UNIVERSITY & RIDGE ADDITION WICHITA, SEDGWICK COUNTY, KANSAS

RE: SUB 2003-05 -- One-Step Final Plat of University and Ridge Addition

RE: SUB 2003-05 -- One-Step Final Plat of University and Ridge Addition

CASE NUMBER: SUB 2003-05 -- UNIVERSITY AND RIDGE ADDITION

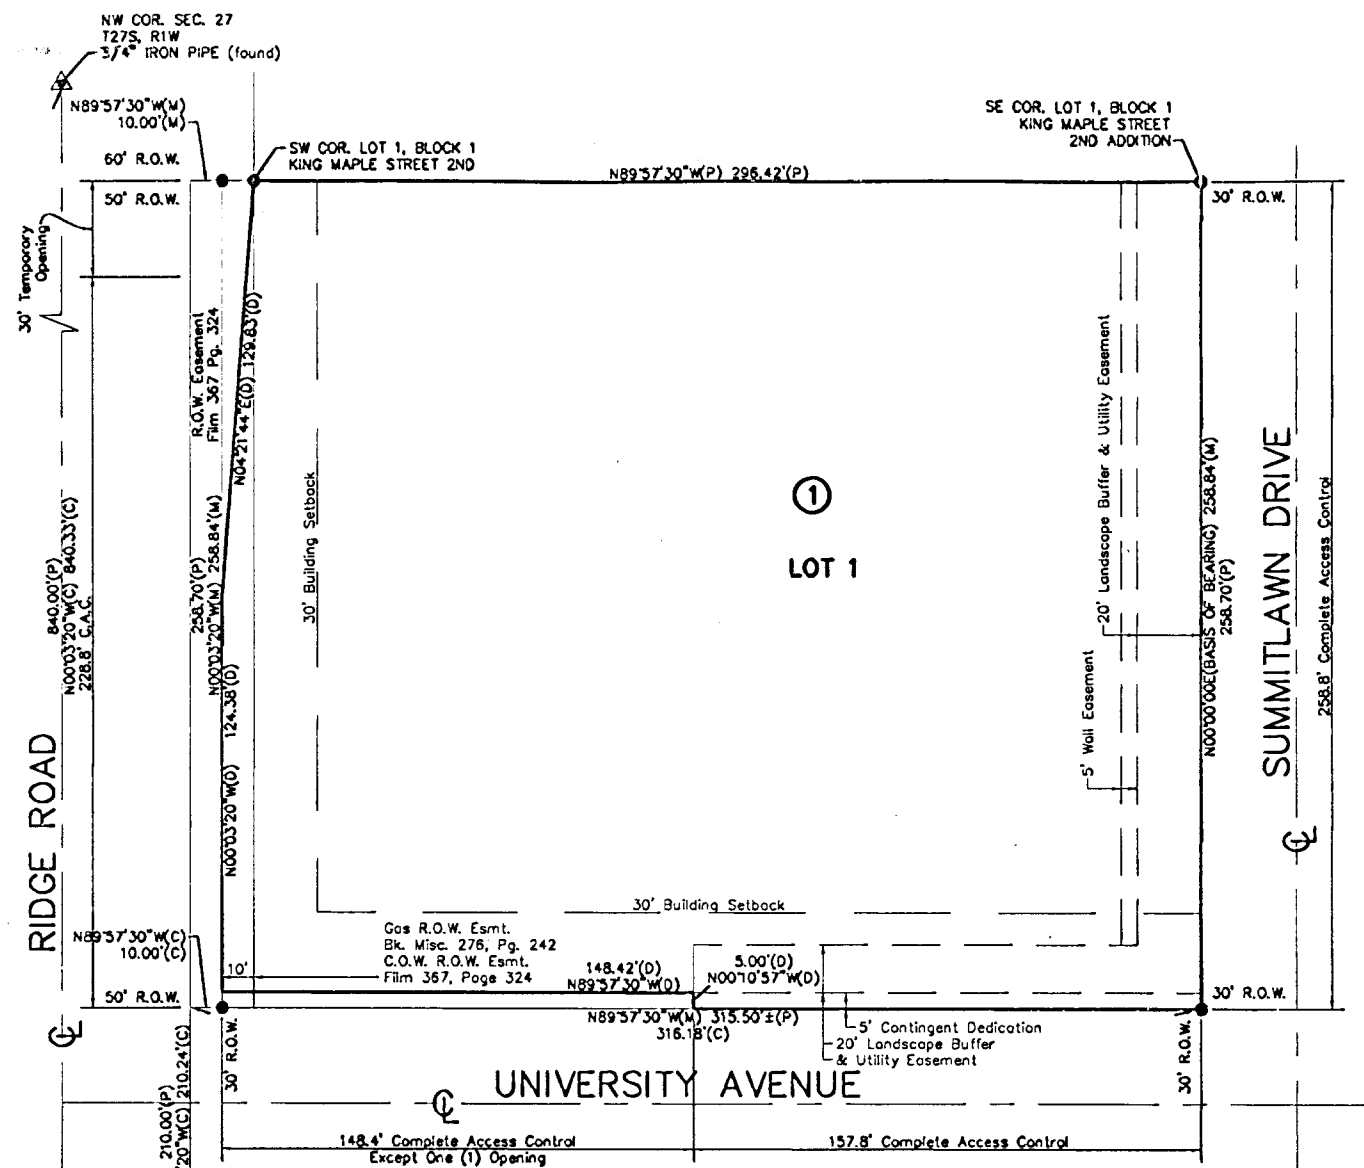
- A. Municipal services are available to serve the site.
- B. A utility easement needs to be platted for the existing sanitary sewer line and electric line.

- D. **City Engineering** needs to comment on the status of the applicant's drainage plan. **The drainage plan needs revised. A private stormwater extension will be needed at time of site development.**

- E. The plat proposes one access opening along both Ridge Road and University along with a 15-ft contingent opening along the north property line. A cross-lot access easement was approved for the property to the north (King's Maple Third Addition) through a 30-ft opening for the benefit of this property. Distances should be shown for all segments of access control. **One opening along University is approved although no left turns out are permitted. A 30-ft temporary opening along Ridge at the north property line is approved which shall be closed when an adjoining opening to the north is constructed. A cross-lot access agreement with the property to the north shall be provided that grants access rights to the owner of this plat within the west 50 feet of the property to the north.**

- F. **Traffic Engineering** has requested the dedication of 10 feet of additional right-of-way along Ridge Road to conform with the 60-ft half-street right-of-way required by the Access Management Regulations.

- G. **Traffic Engineering** has requested an additional 5 feet of right-of-way along University Avenue. The Subdivision Regulations require a 70-ft half-street right-of-way for a commercial street. **A 5-ft contingent dedication has been platted for a portion of this right-of-way which has been approved.**

- K. **County Surveying** has requested a precise location for the benchmark.
- L. The legal description needs revised to delete the language "being replatted as...".

- M. The applicant is reminded that in addition to the wall easement platted parallel to the east property line, the Protective Overlay also required a wall constructed parallel to the south property line.

- O. The platator's text shall include language that a drainage plan has been developed for the plat and that all drainage easements, rights-of-way, or reserves shall remain at established grades or as modified with the approval of the applicable City or County Engineer, and unobstructed to allow for the conveyance of stormwater.
